TECHNICAL SERVICE BULLETIN

Technical Service Bulletin: 40-1164

Forest River is alerting you to an issue involving certain 2020 - Berkshire - BEA45A-450, BEA45B-450 and BEA45CA-450 Class A Motorhome recreational vehicles. Please see the information below, which describes the issue and provides you with details on the steps you should take to have your vehicle repaired.

2020 BERKSHIRE-XLT 10K GENERATOR RAISE

Fig 1

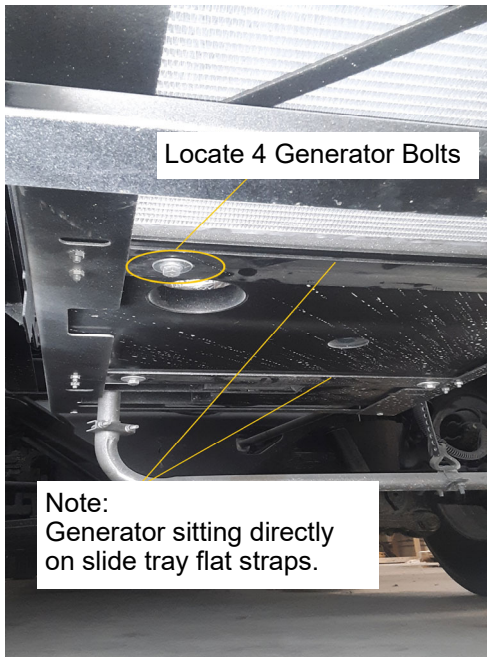
The side access door of the generator may not be able to be opened for servicing.

This Technical Service Bulletin ensures that the side access door of the generator can be opened for servicing on 2020MY units with I.F.S

1. Locate 4 bolts that attach the generator to the slide tray; (Fig-1)
2. Loosen the bolts to a point that they are just started in threads;
3. Place jack and wood block under generator and lift the generator until there is a minimum of 1" gap between generator and the tray; (Fig-2)
4. Remove the front 2 bolts, place the new spacer tube(s) between generator and the flat strap that's installed in the slide tray; (Fig-3)
5. Insert the new longer bolts;
6. Repeat steps 4 & 5 for rear bolts;
7. Lower generator and remove jack;
8. Tighten new bolts.
